# ADDENDUM #2

February 4, 2026
CGMH NEW NUCLEAR MEDICINE SPECT/CT SUITE RENOVATION PROJECT
Job Number: 24-200
To: All Bidders, All Consultants, Project Manager
Number of Pages : 44

01 A201 FLOOR PLAN - LEVEL B1
1/4" = 1'-0"

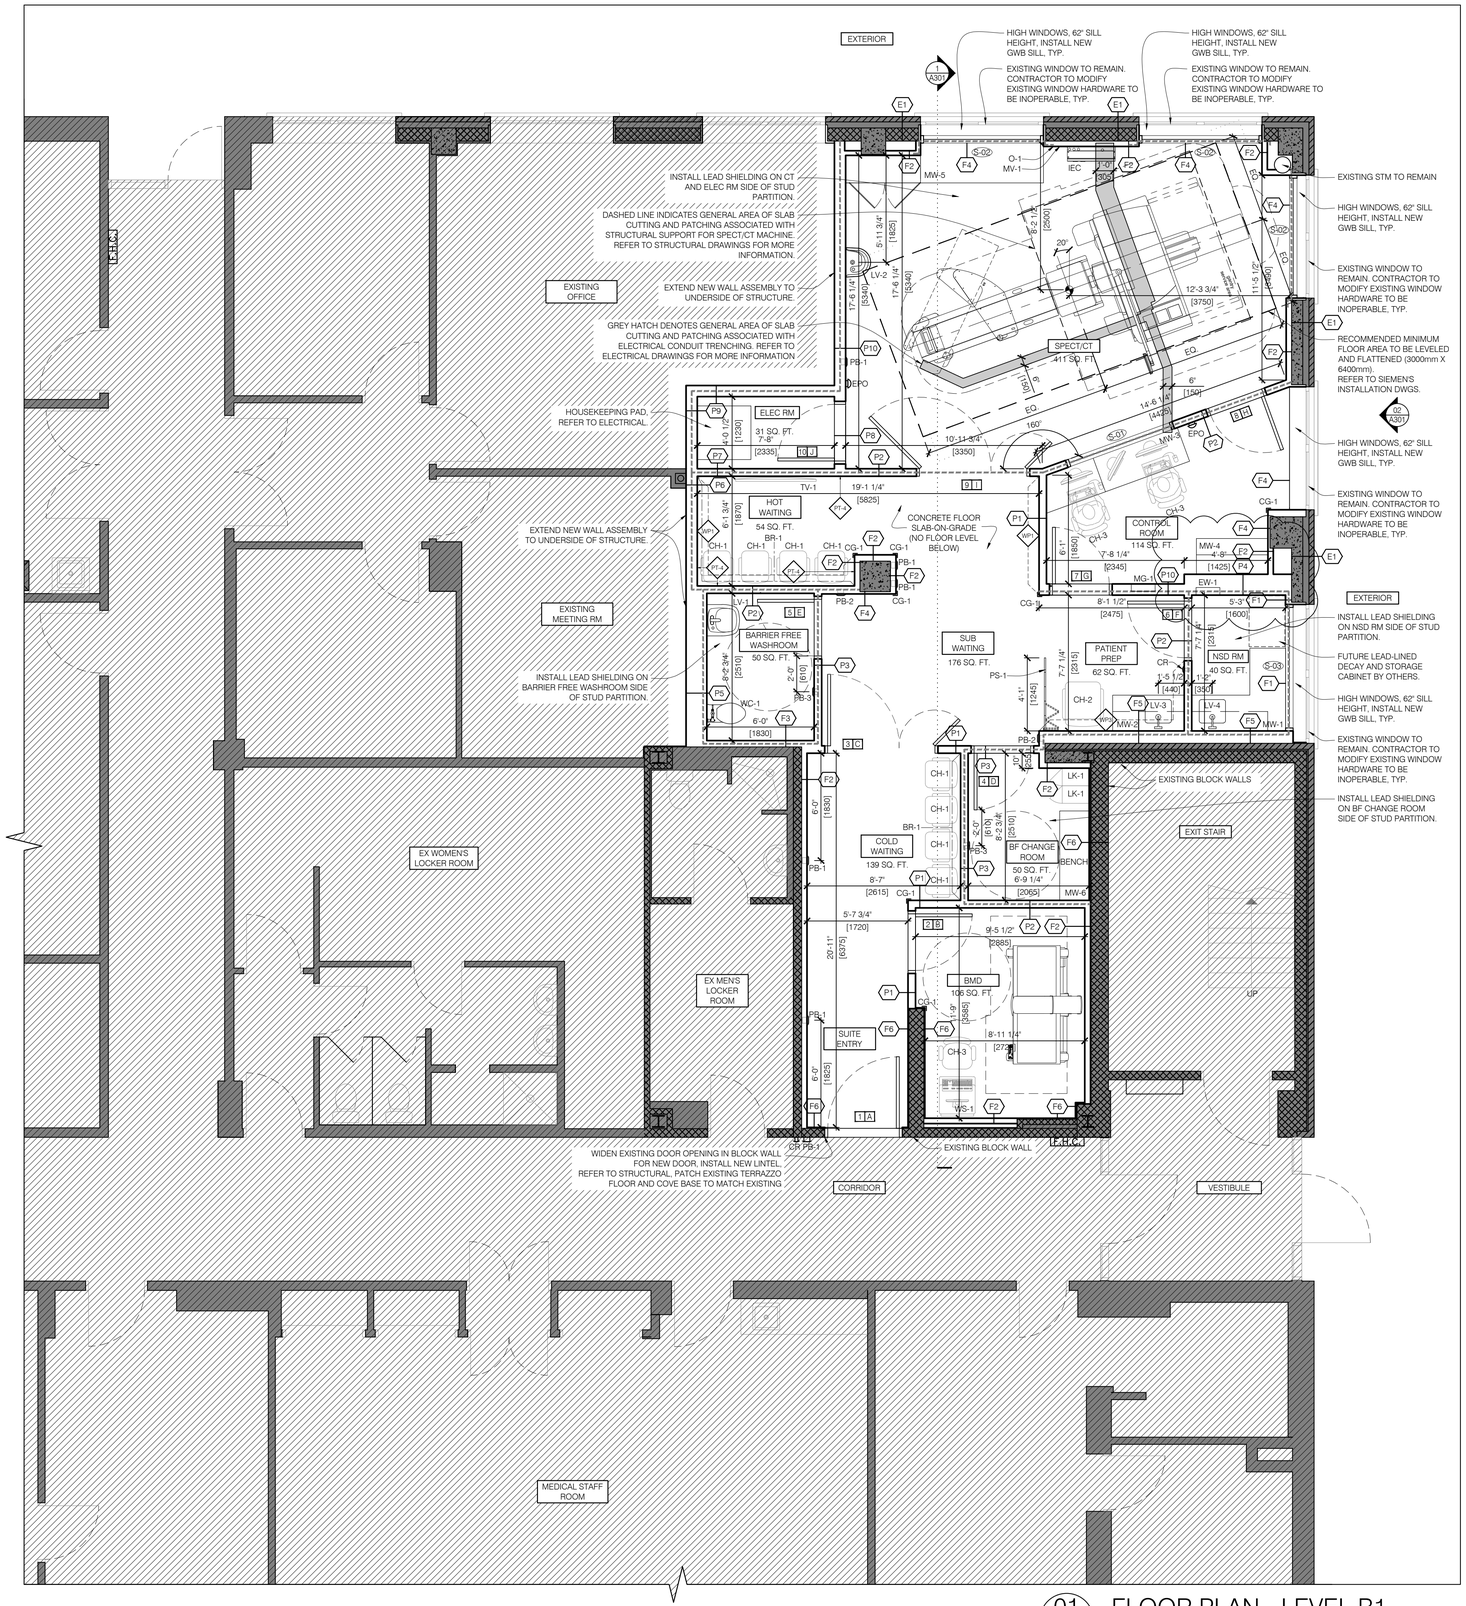
**Q16** WP-1, WP-2, and WP-3 are to be provided in accordance with both the Finish Schedule on Sheet A-003 and the Floor Plan on Sheet A-201. The drawings are to be read together. Where wall protection is required on all walls within a space, it is identified in the Finish Schedule. Where wall protection is required on select walls only, this is identified by notes/symbols on the floor plans.

1. Refer to revised sheet A-003 (attached): **ADD** P4 wall assembly.
2. Refer to revised sheet A-201 (attached): **REVISE** wall assembly to P4.
3. Refer to revised sheet A-202 (attached):
    a. **ADD** light fixture in SPECT/CT Room.
    b. **REVISE** wall to align with plan revision.
4. Refer to attached **Mechanical Addendum M-02.**
5. Refer to attached **Electrical Addendum E-02.**

1 M200 MECHANICAL BELOW GRADE PLUMBING PLAN - DEMOLITION
SCALE: 1/4" = 1'-0"

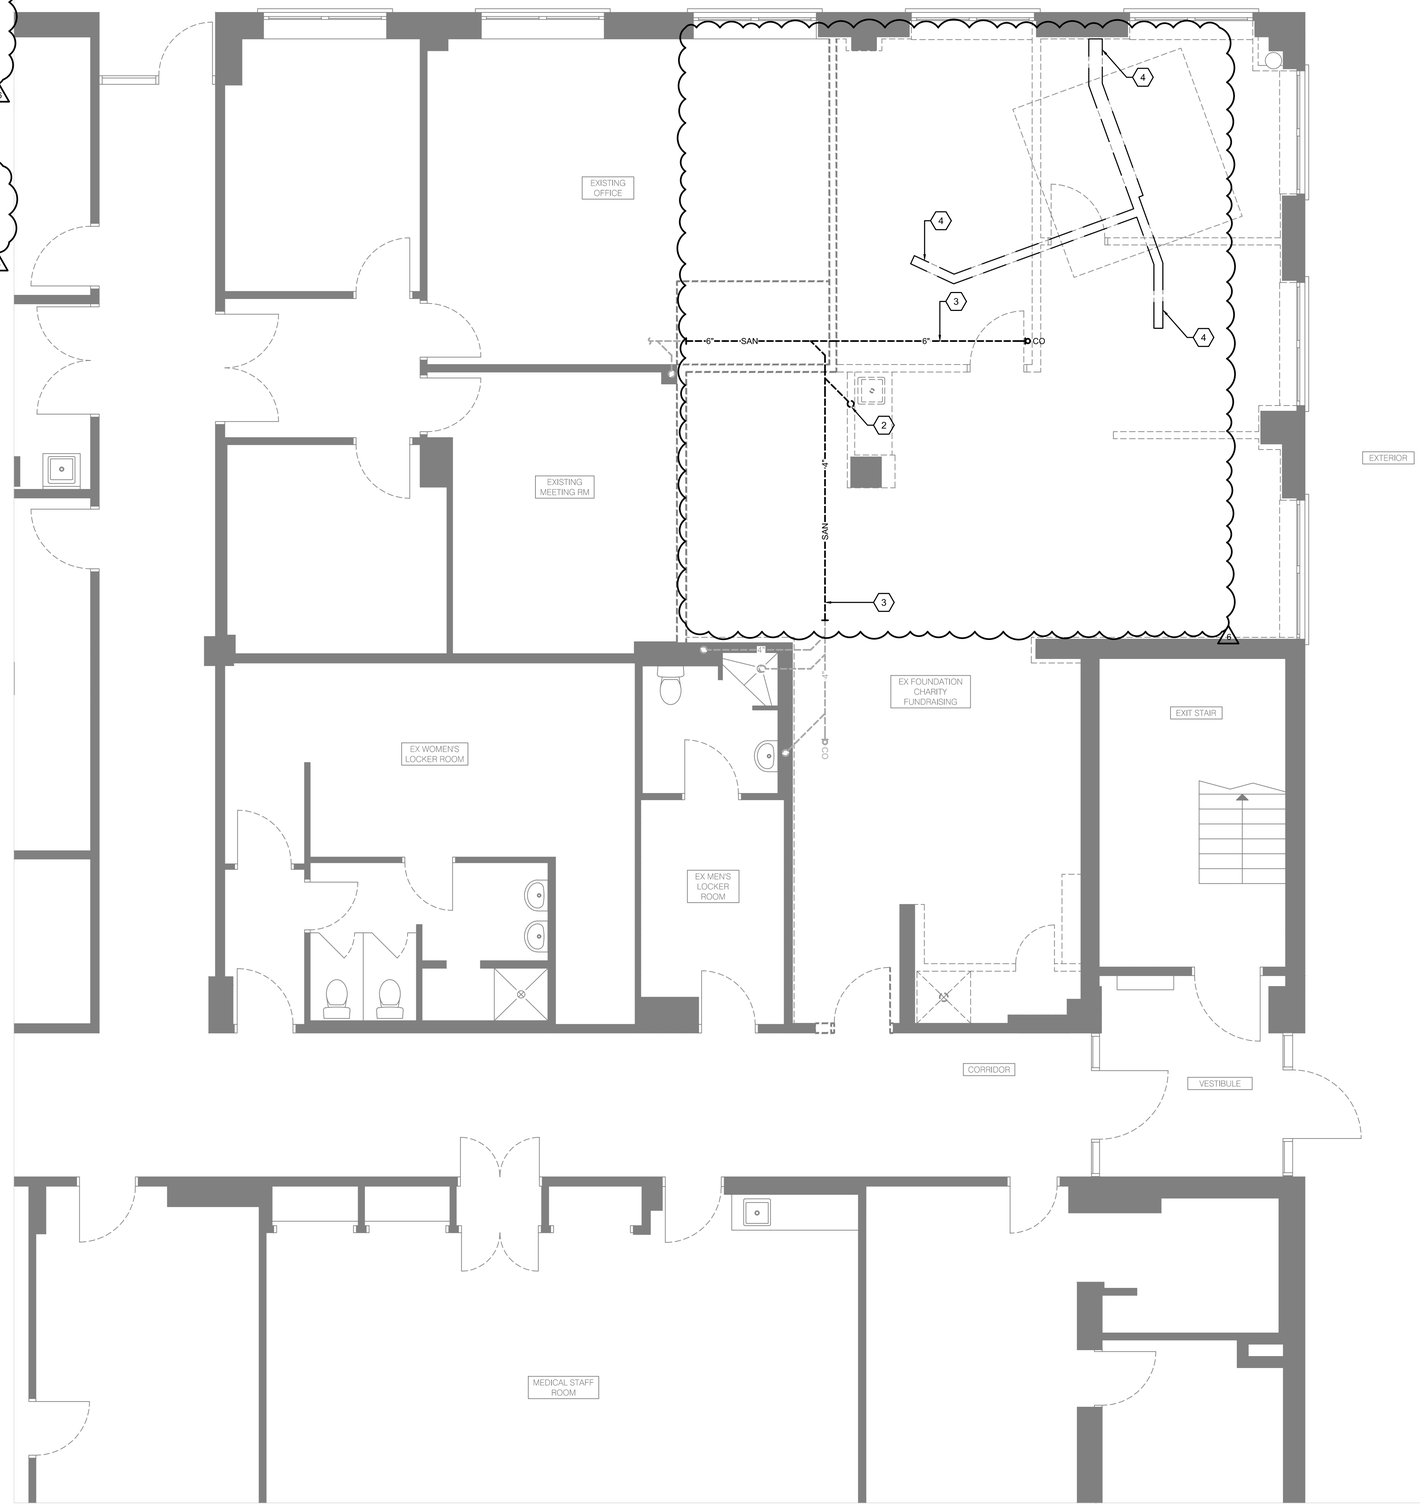
1. **Drawing M-200 – MECHANICAL BELOW GRADE PLUMBING PLAN -DEMOLITION**

- Added general notes.

- Added underground sanitary demolition scope.

- Added electrical conduit path reference note.

1 M201 MECHANICAL PLUMBING PLAN - DEMOLITION
SCALE: 1/4" = 1'-0"

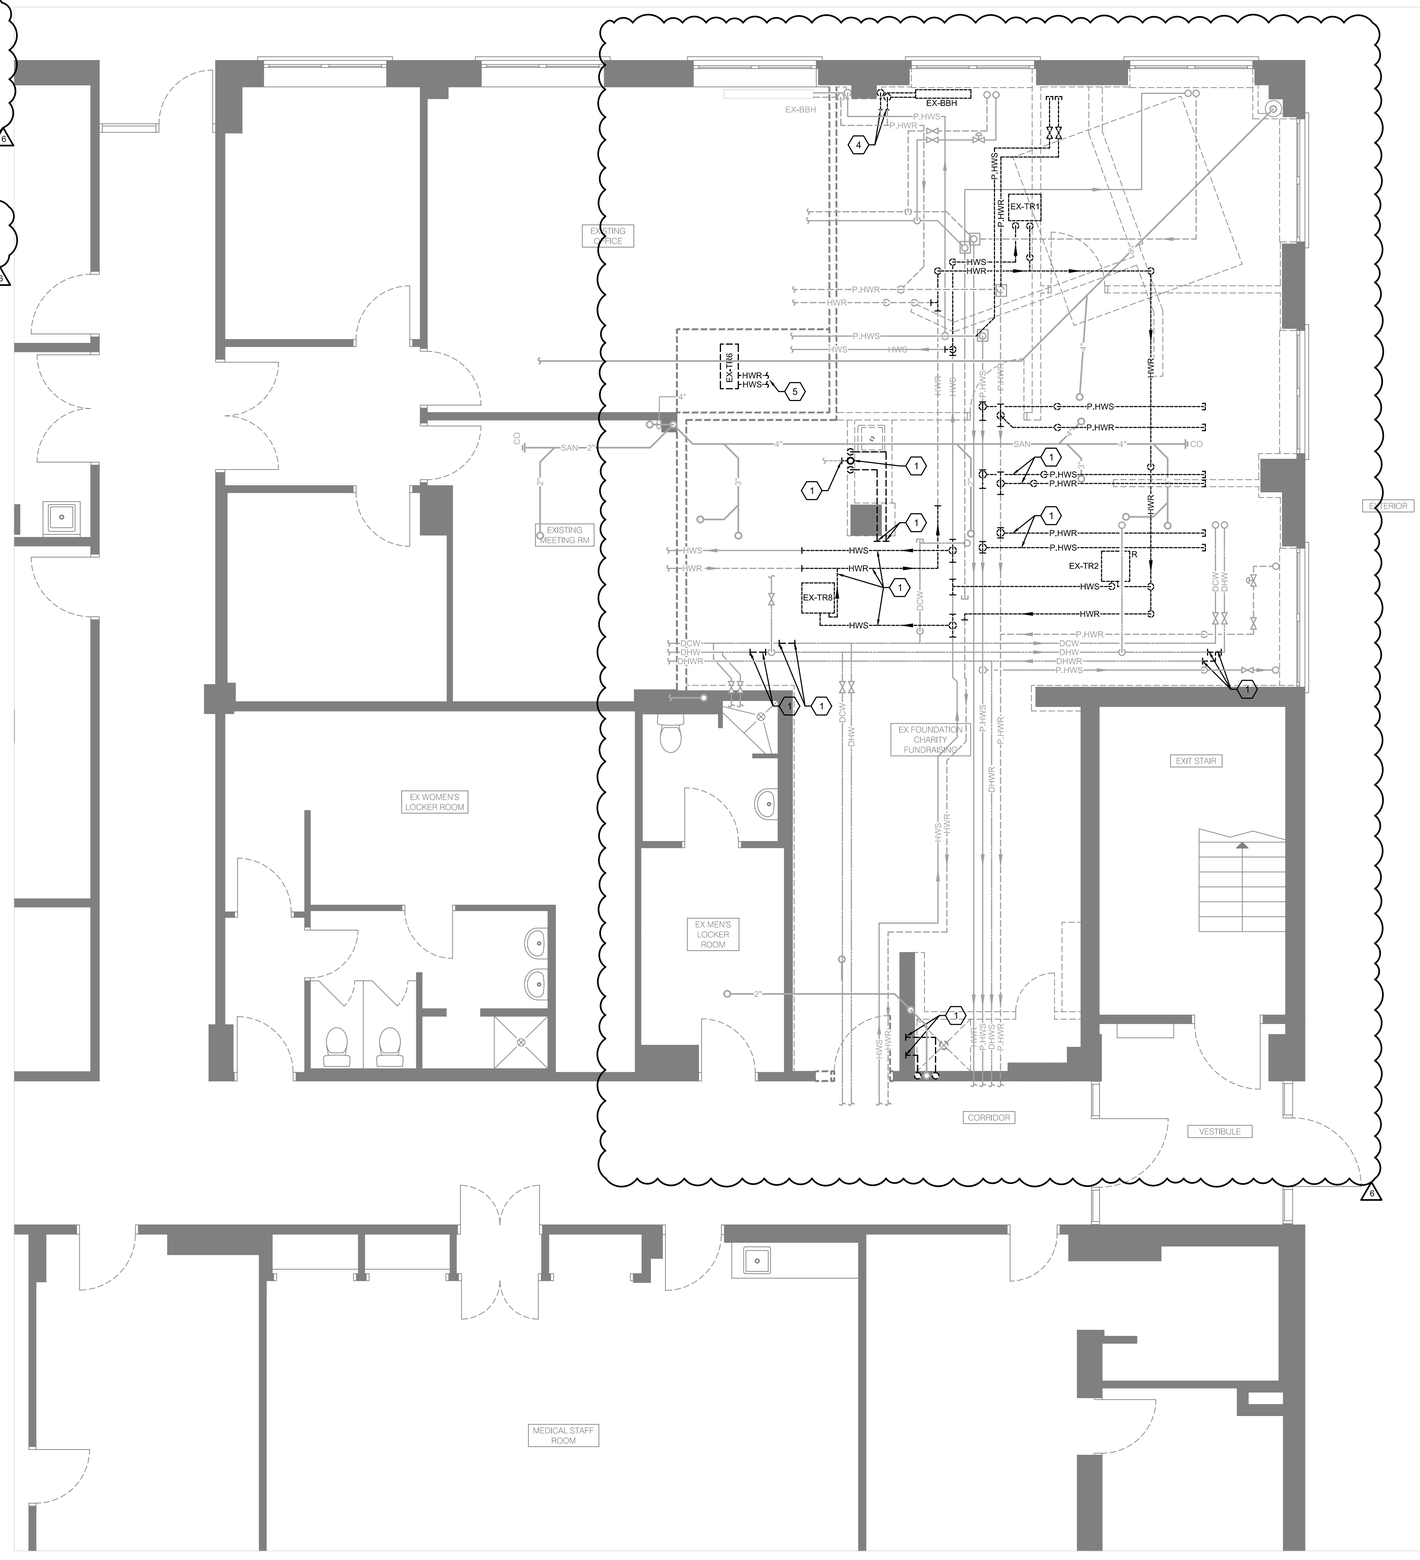
2. **Drawing M-201 – MECHANICAL PLUMBING PLAN - DEMOLITION**

- Added general notes.

- Revised demolition scope of hydronic piping as shown on drawing.

- Added existing Hydronic piping network to drawings.

- Updated existing DCW and DHW lines arrangement as shown on drawing.

1 M202 MECHANICAL BELOW GRADE PLUMBING PLAN - NEW WORK
SCALE: 1/4" = 1'-0"

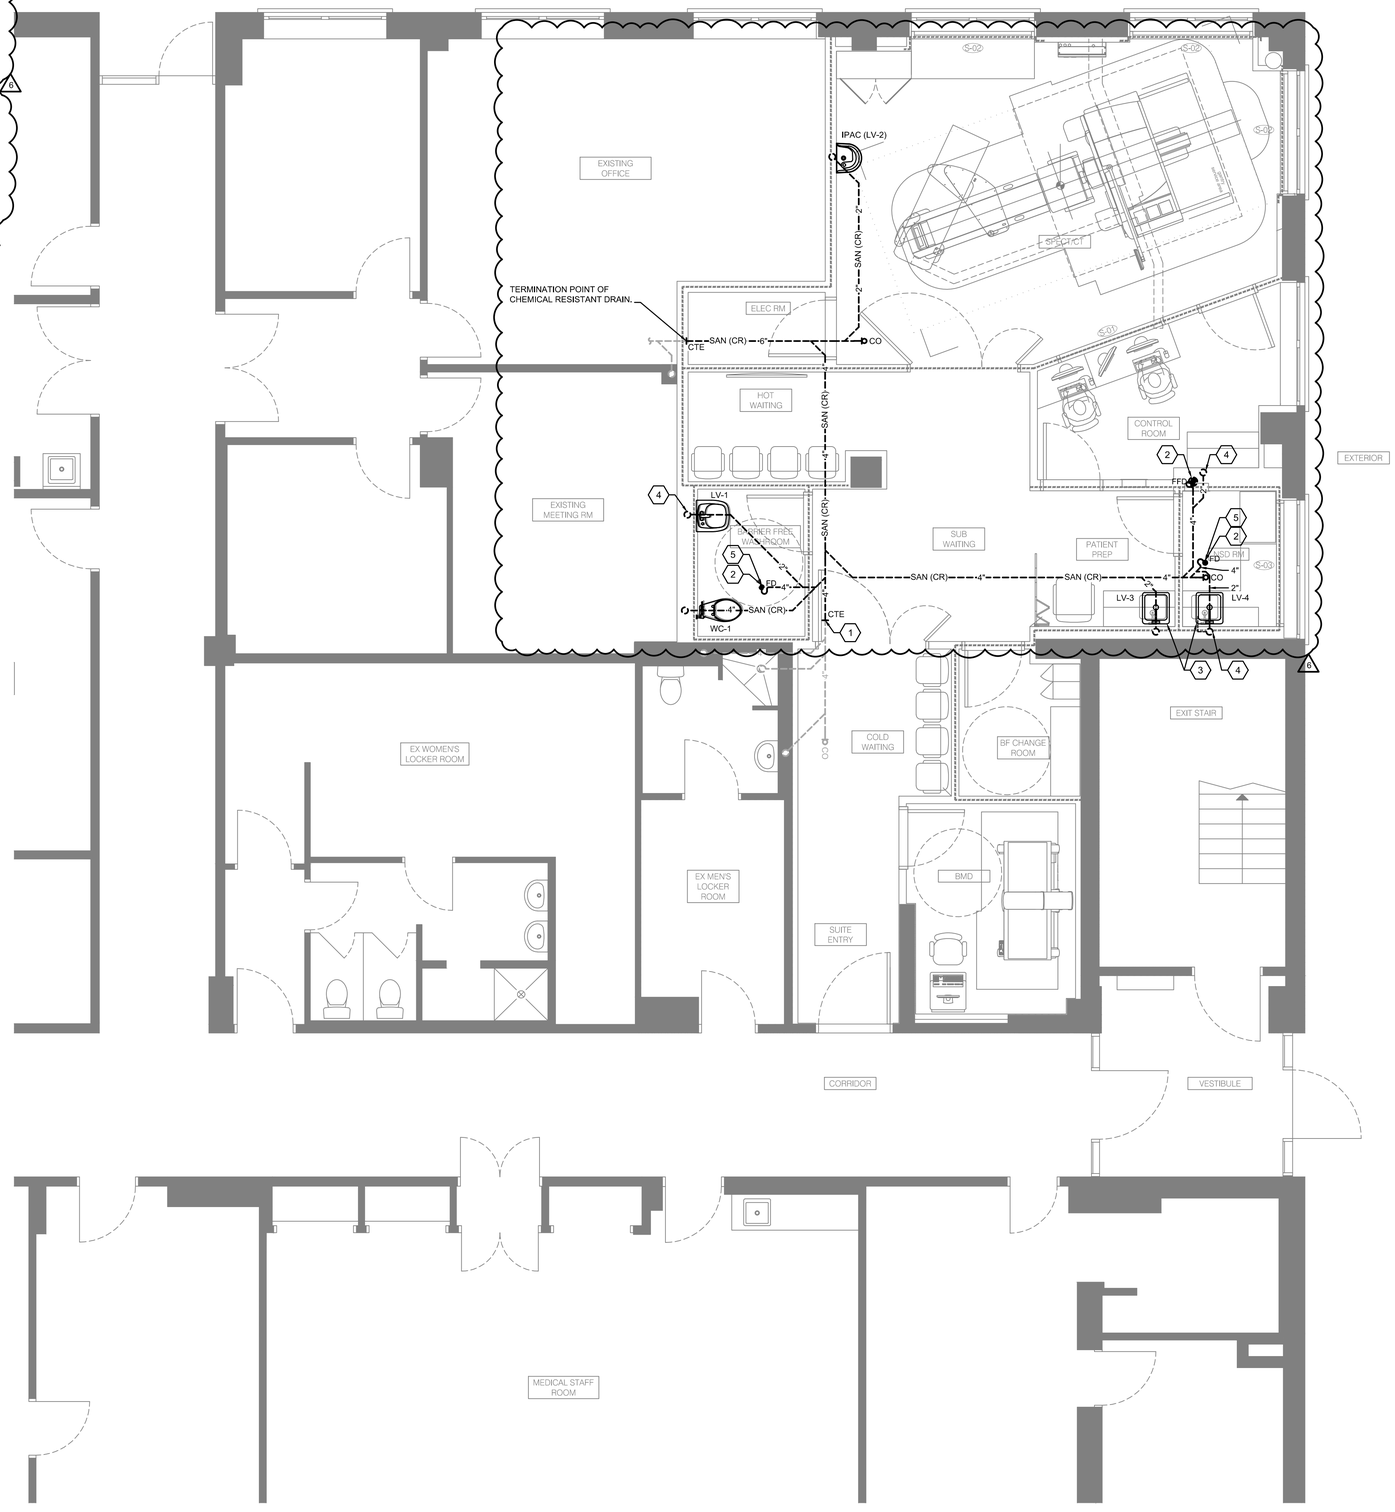
3. **Drawing M-202 – MECHANICAL BELOW GRADE PLUMBING PLAN -NEW WORK**

- Added general notes.

- Added underground sanitary new work scope and underground sanitary specification to SAN (CR) chemical resistant, sizes adjusted as shown on drawings.
